ADDENDUM No. 1

March 7, 2023

BID DOCUMENTS dated 02/06/2023

CITY OF CANTON – SANITATION BUILDING PROJECT – GP 1376

SWPP PLAN

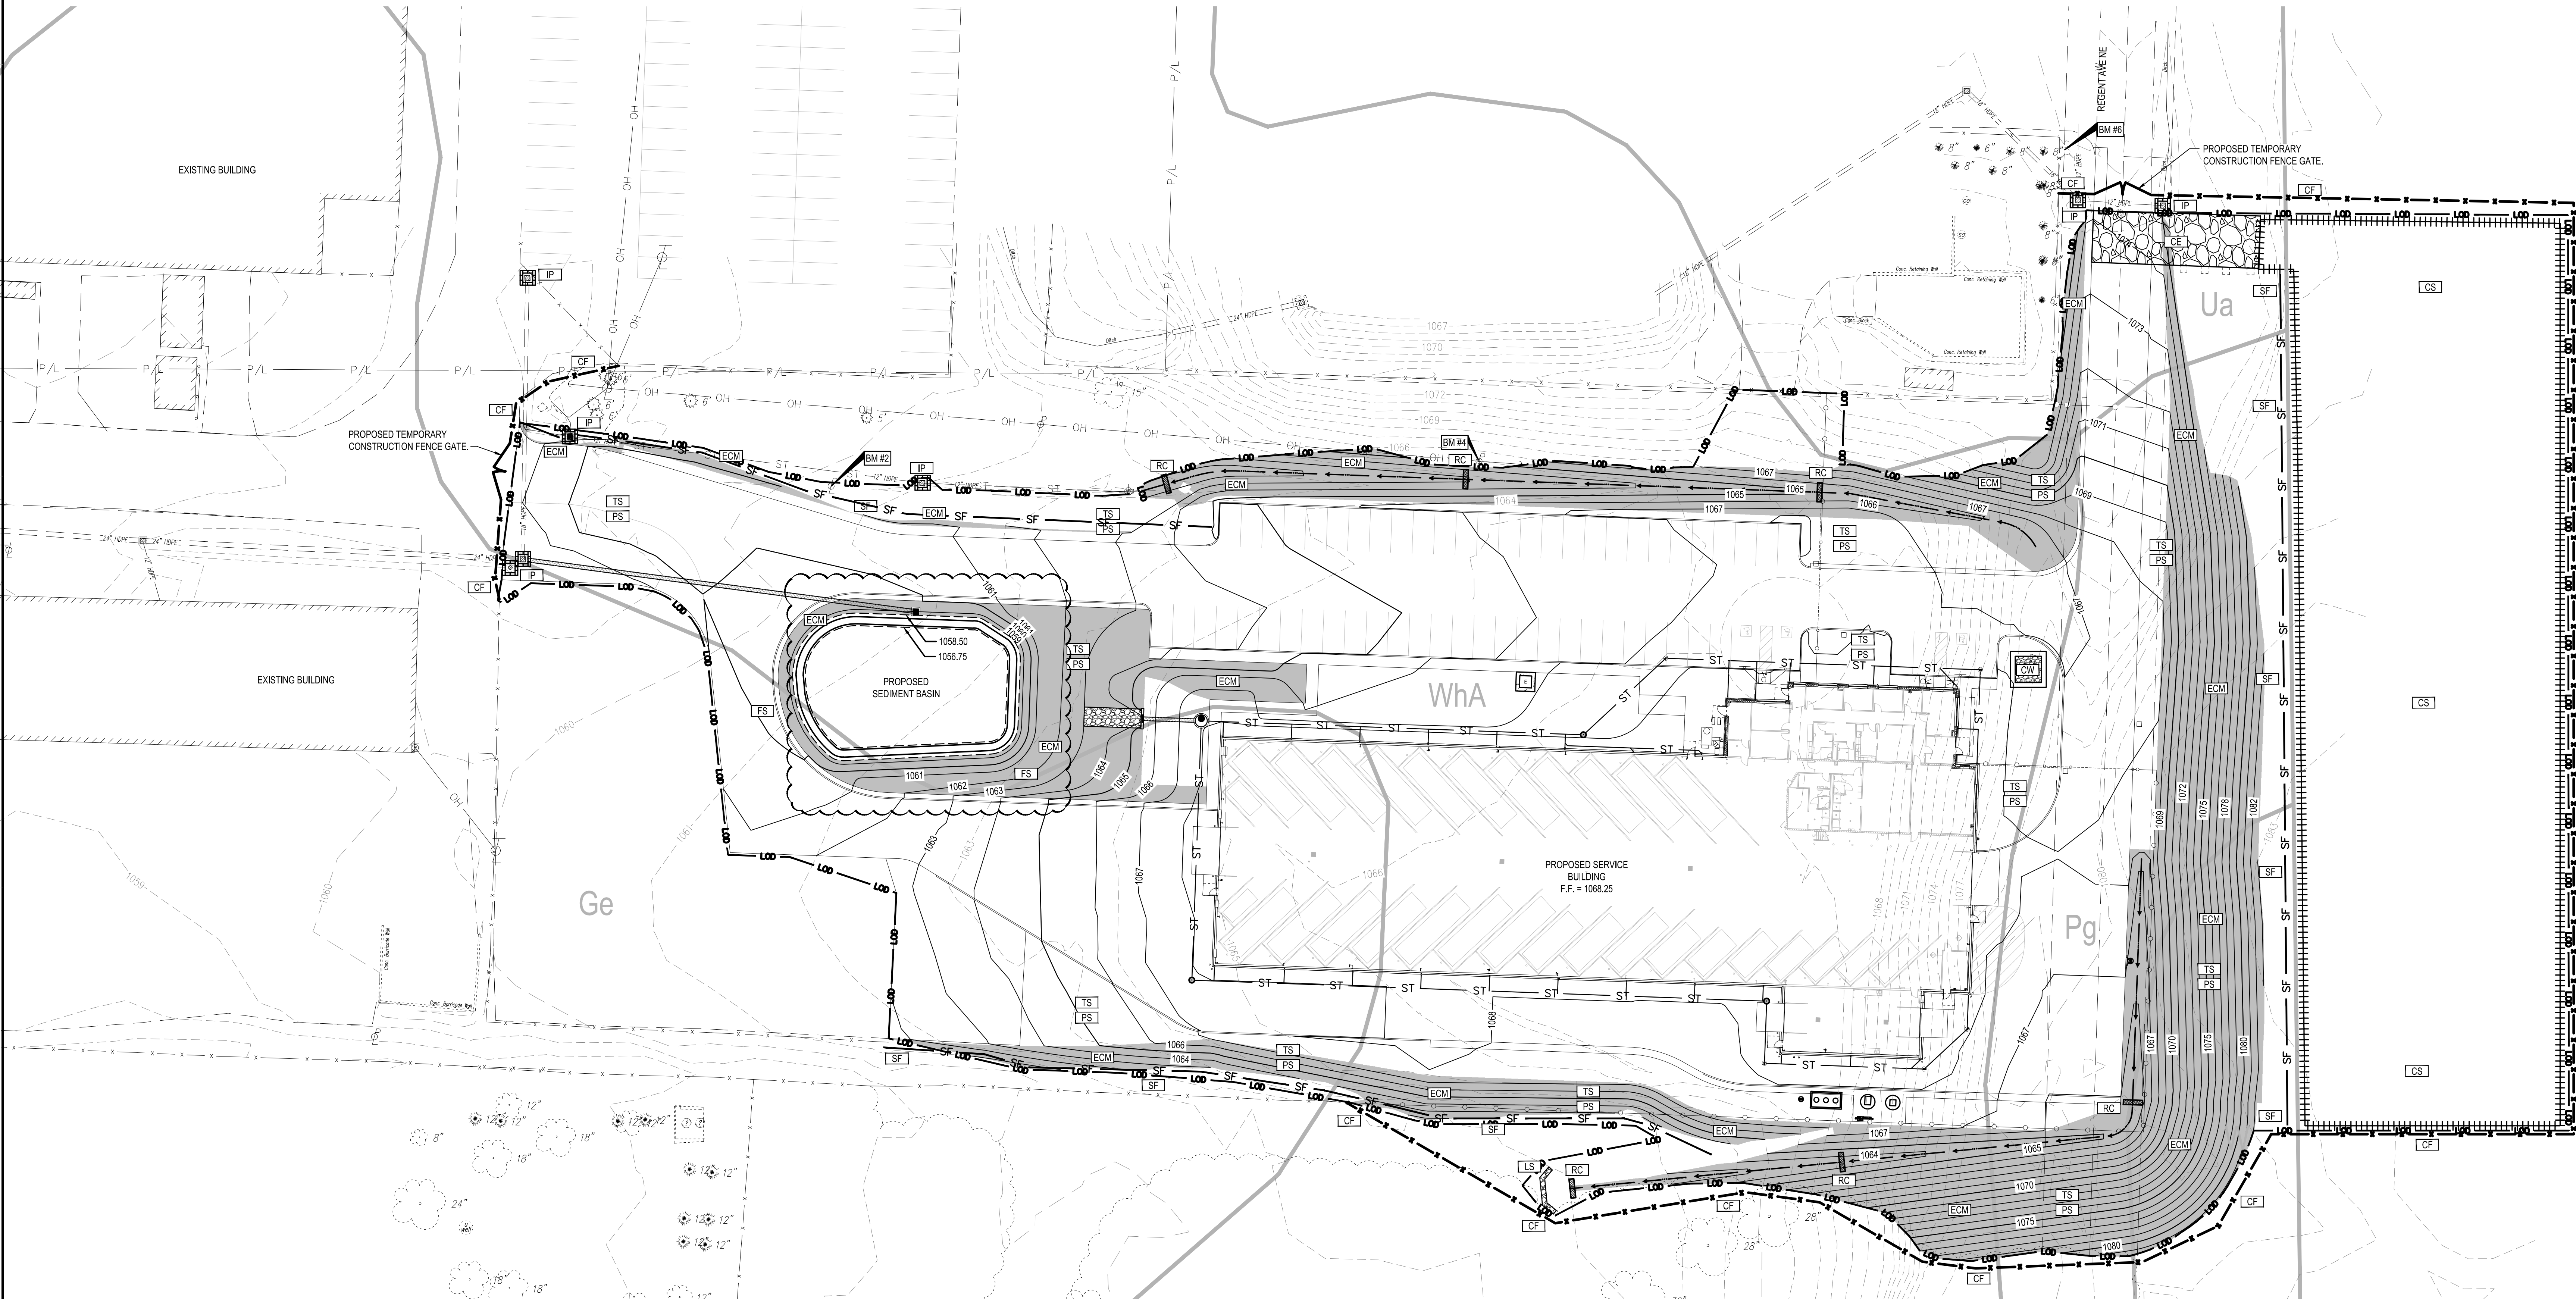
1. TS-001 TITLE SHEET
 - a. Added sheet C-013 SWPP DETAILS to the drawing index.
2. C-011 SWPP PLAN
 - a. Added Construction Sequence Note 1.1
 - b. Added Bioretention and Topsoil Stockpile boxed note.
 - c. Added Sediment Basin
3. C-012 WATER QUALITY PLAN
 - a. Updated Bioretention soil media notes #3.
 - b. Revised Plan Elevation G.
 - c. Added Bioretention Filter Media Drawdown Calculations.
 - d. Revised plan bioretention callouts.
4. C-013 SWPP DETAILS
 - a. Added sheet
5. C-101 DEMOLITION PLAN
 - a. Removed Catch Basin.
 - b. Revised Plan Keynote #4.
6. C-111 SITE PLAN
 - a. Revised Motorized Gates and motor location.
 - b. Revised keynotes #15 and #16.
 - c. Added Proposed Catch Basin.
 - d. Curbing from Garage door changed to being Flush curb until 6' curb taper by flag pole.
7. C-121 GRADING PLAN

C-111

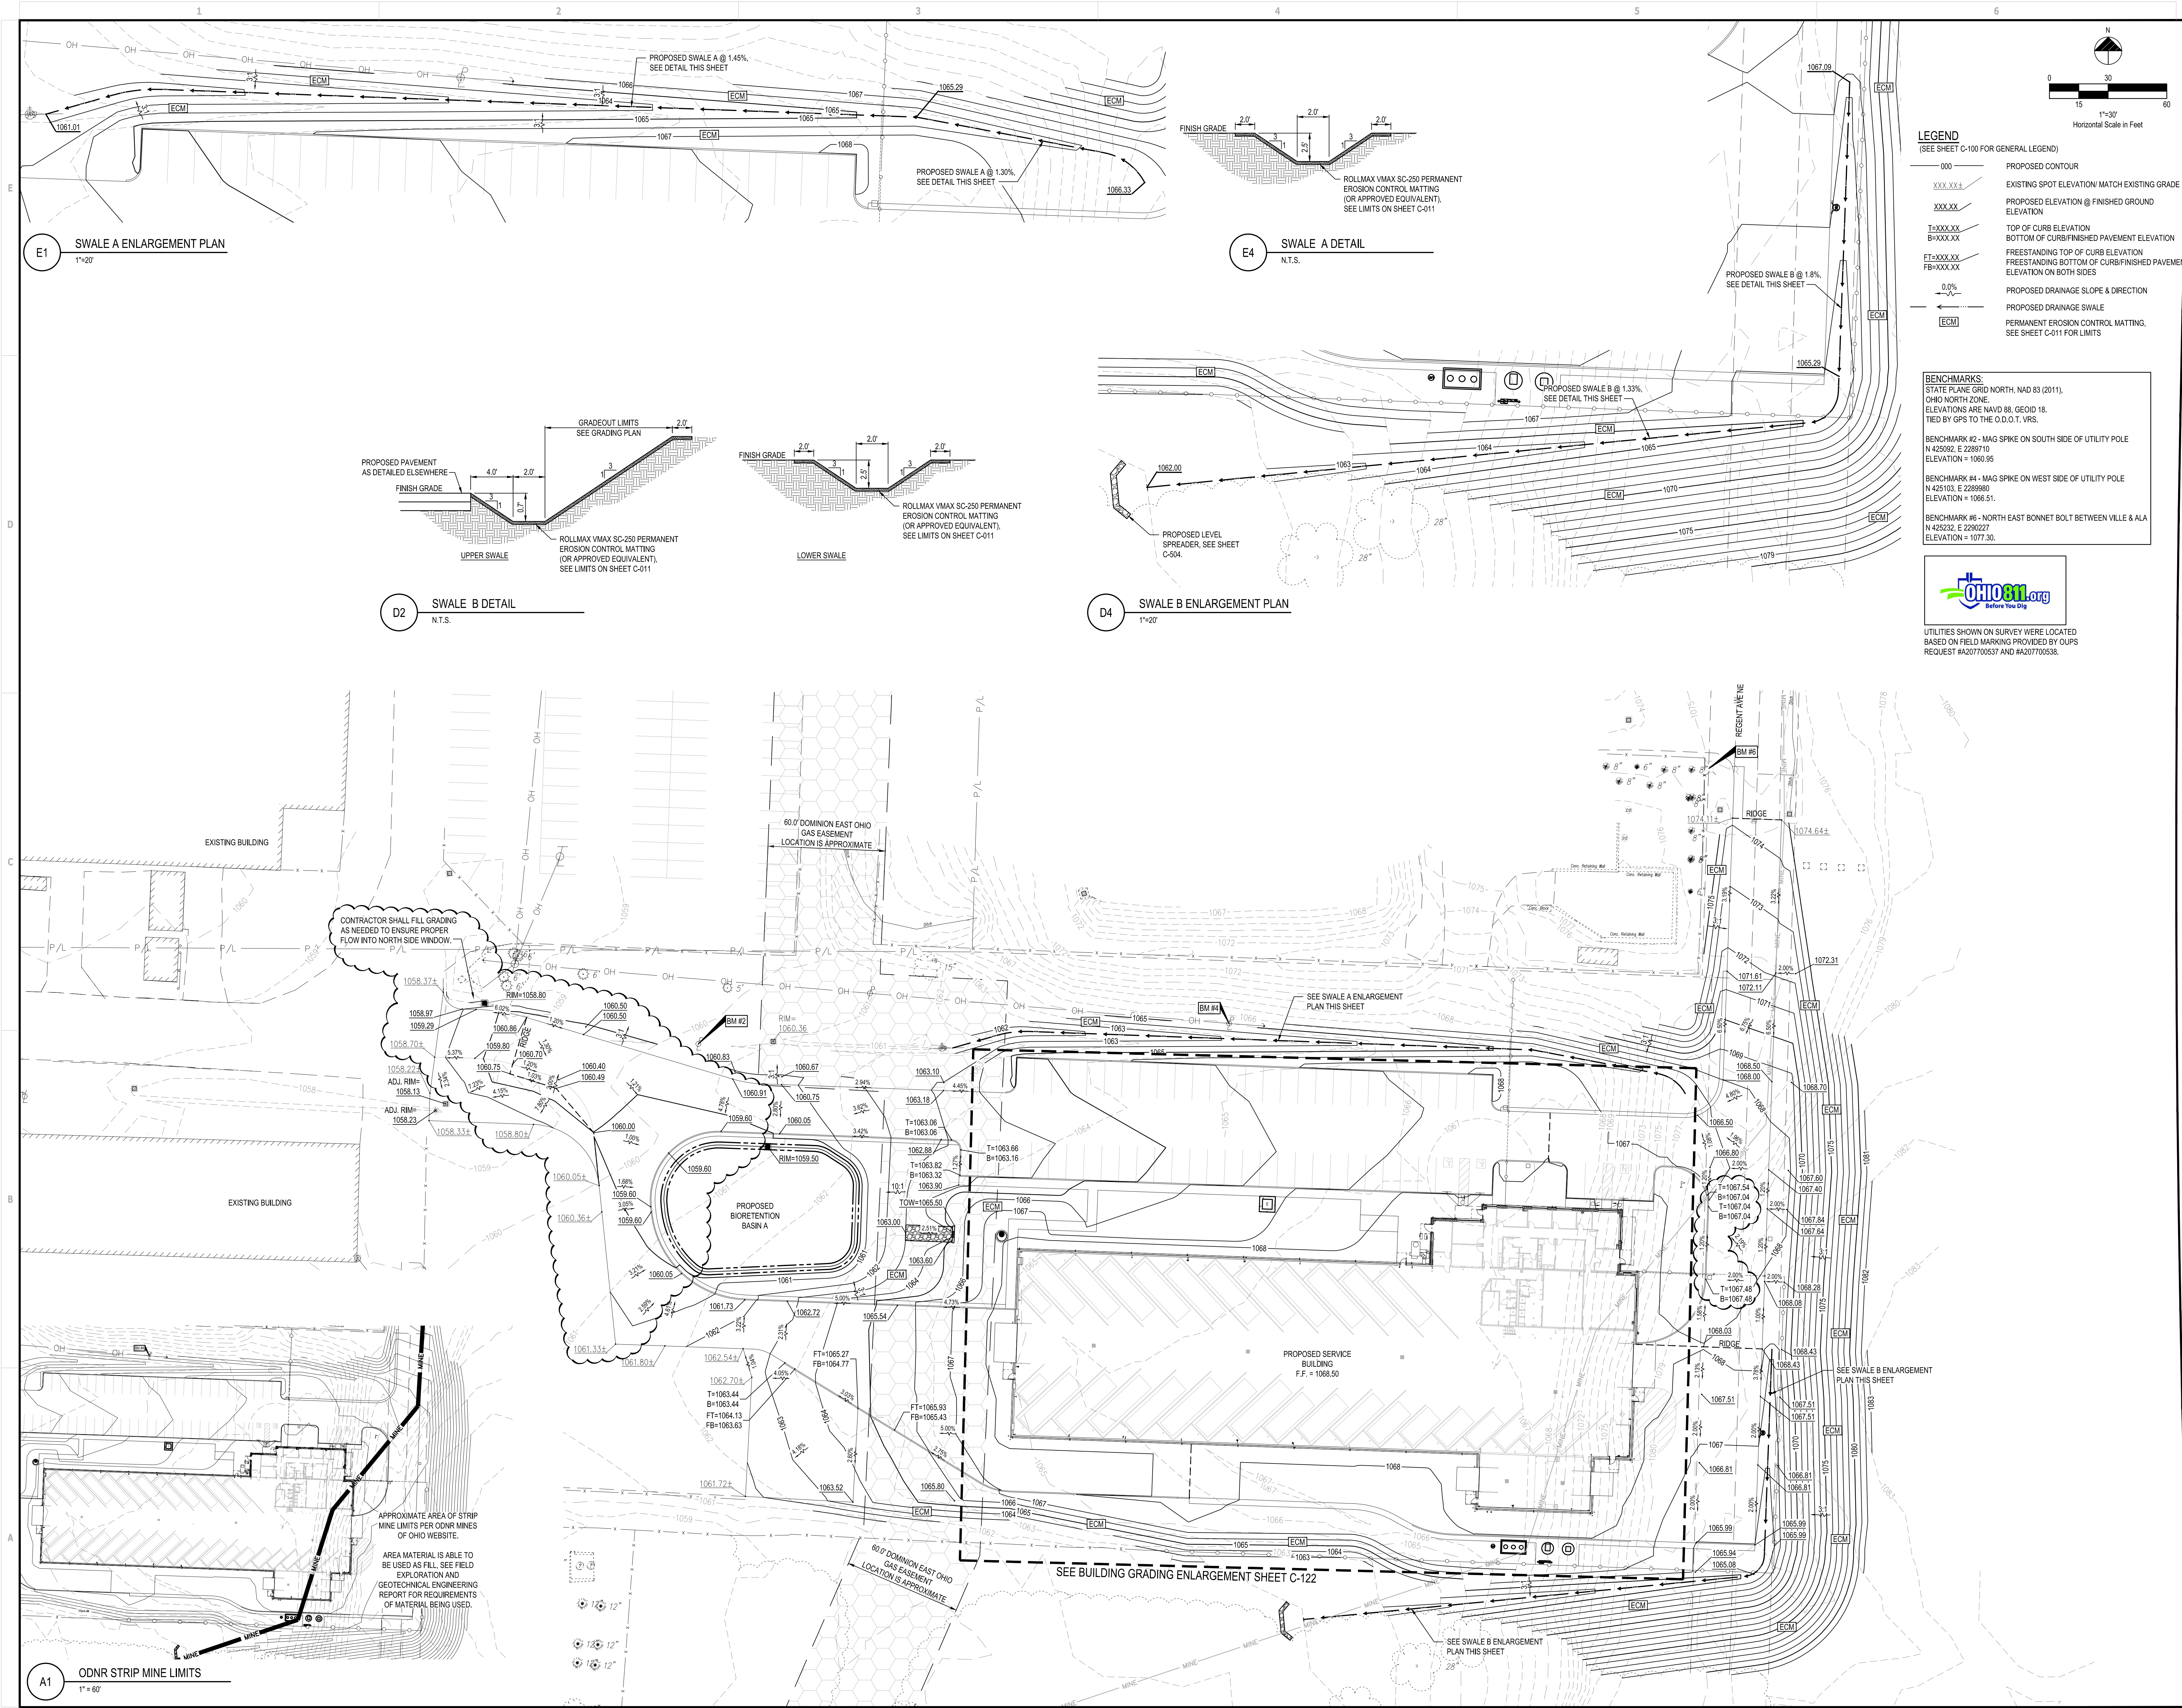
11. *Question: The proposed gravel berm seems to have note 2 (flush curb) next to everywhere except for the curved area in the Northeast corner of the parking lot by Regent Ave. Do I need flush curb there as well? Page C111.*

Response: Flush curbing is not required here.
12. *Question: Is the permit cost a pass-through cost back to the owner?*
Response: The City of Canton will waive city building department fees. Permits are still required but the fee is waived. All City inspections shall be coordinated/scheduled by the contractor.

C-122

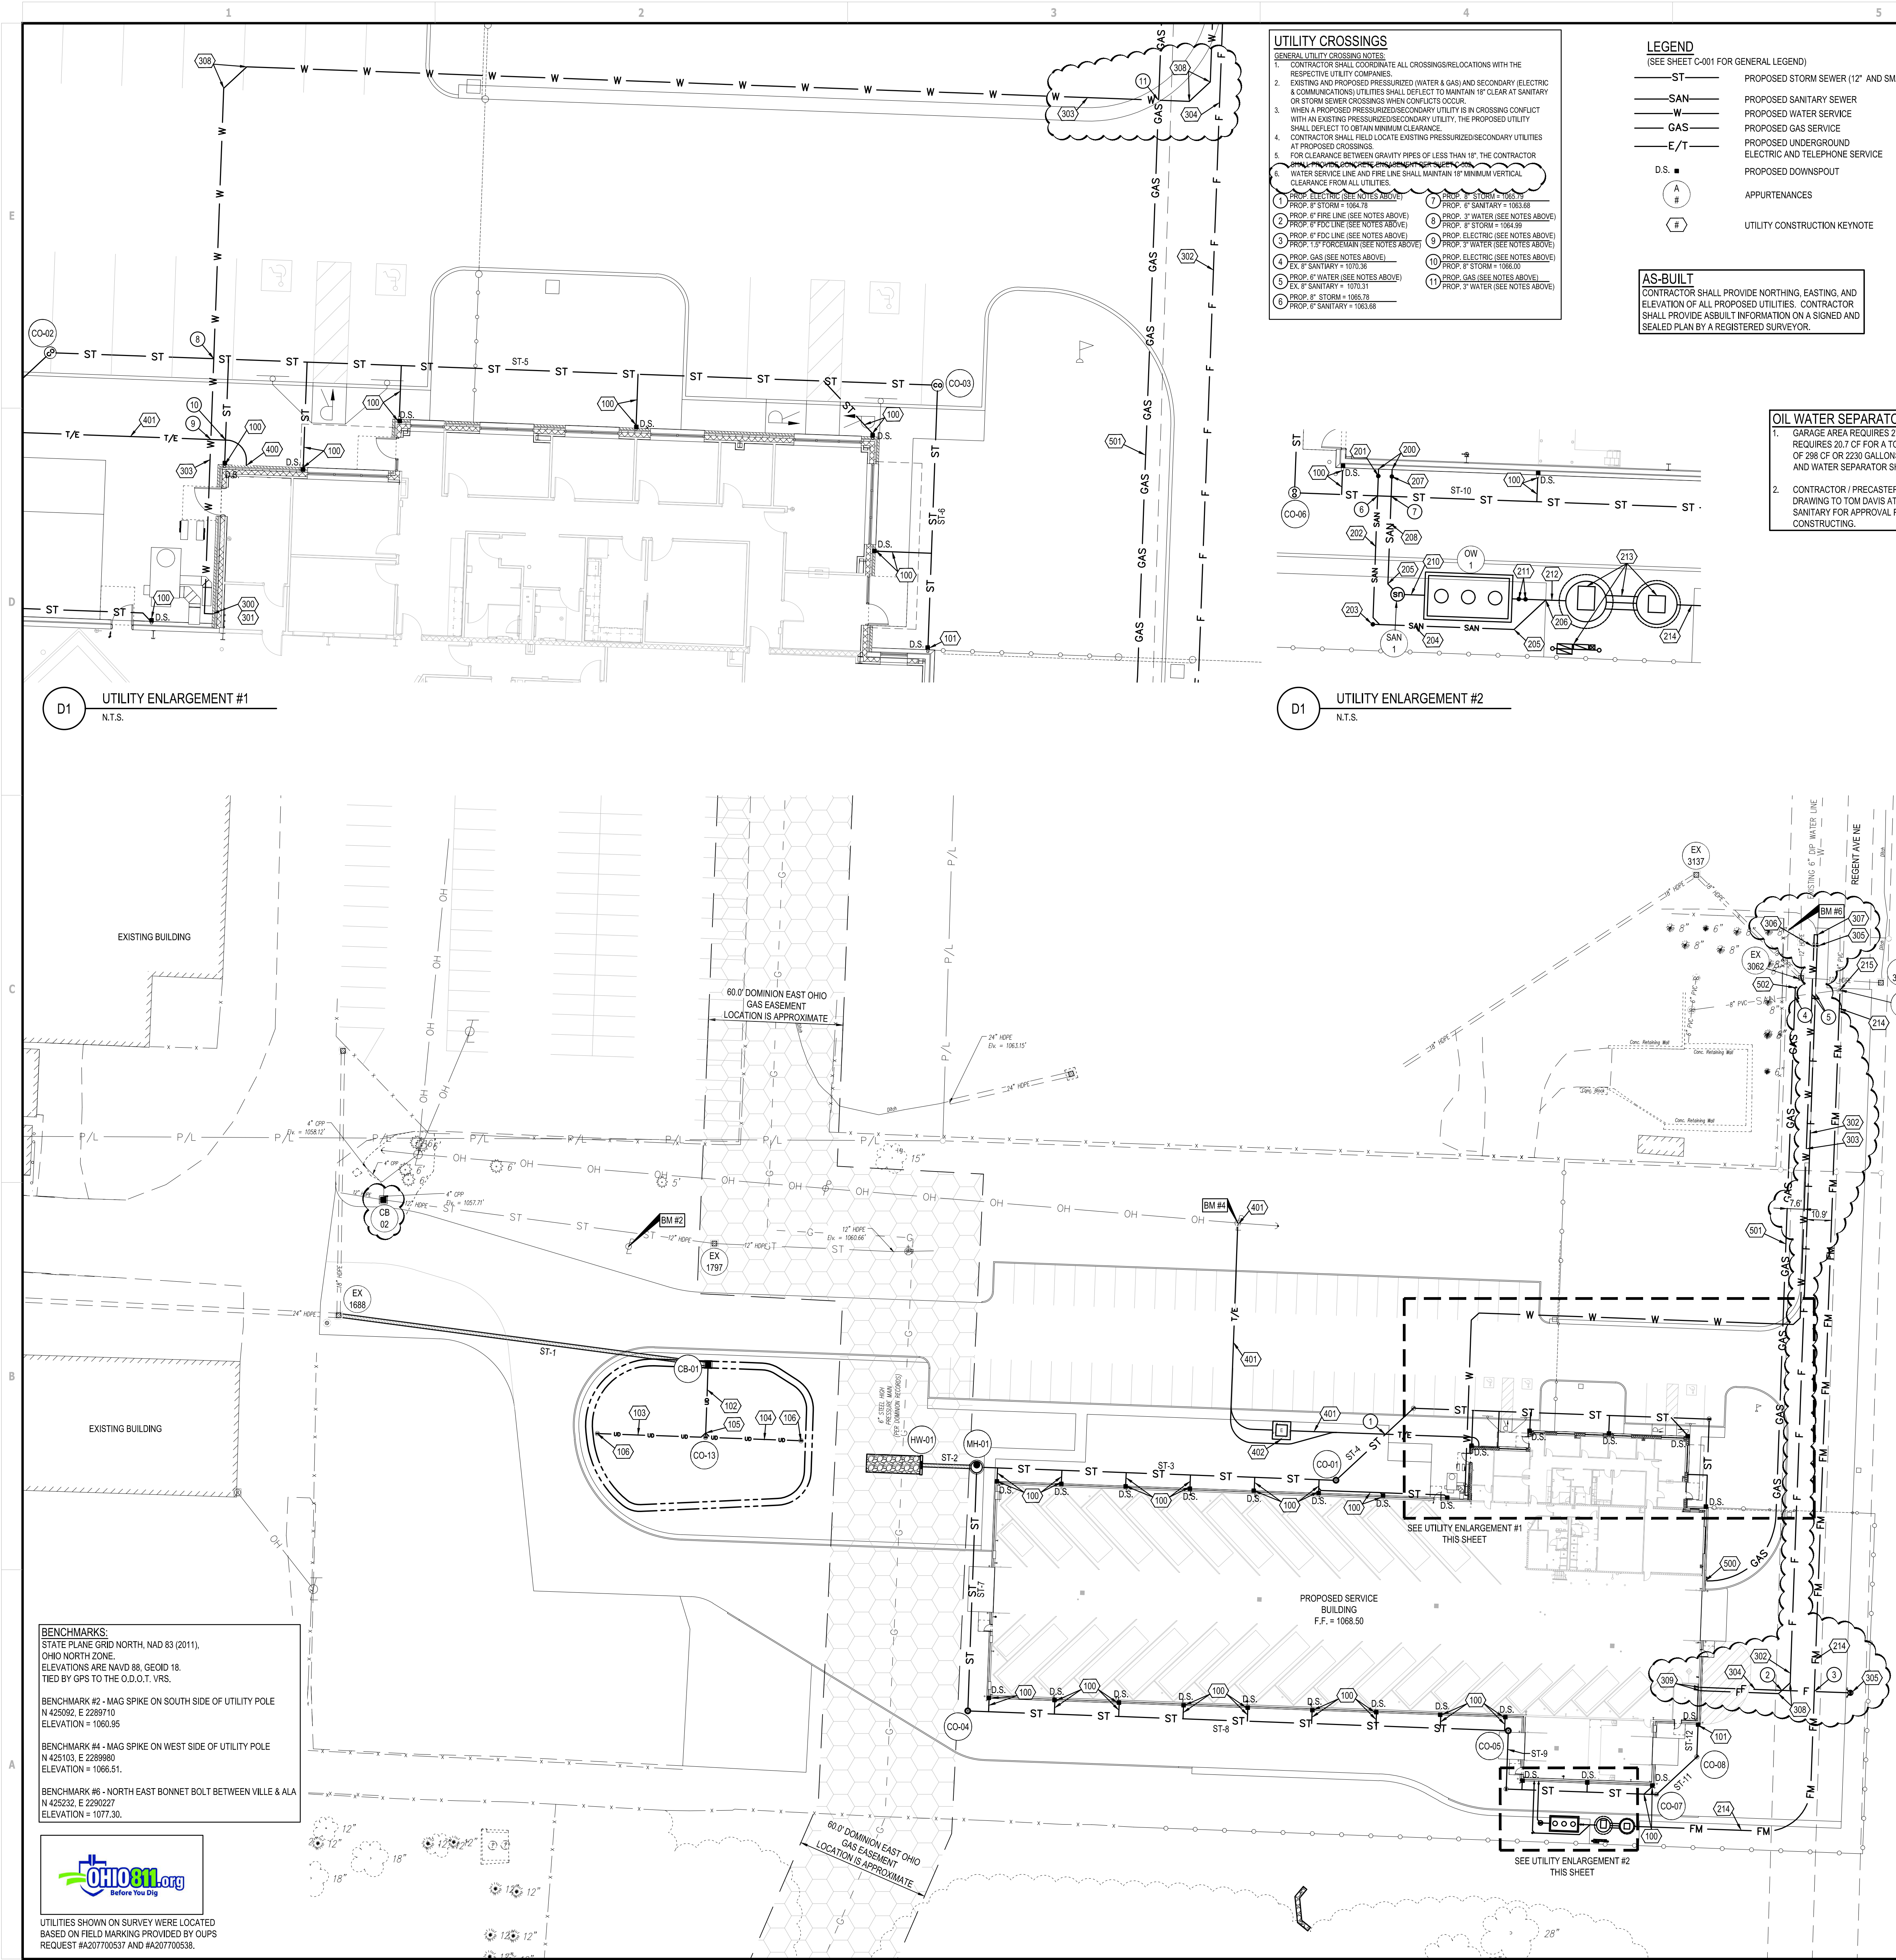
- 8. C-122 GRADING ENLARGEMENT
 - a. Revised curbing at garage to show flush curbing.
- 9. C-131 UTILITY PLAN
 - a. Added proposed ODOT 2-2A catch basin with a window on north side.
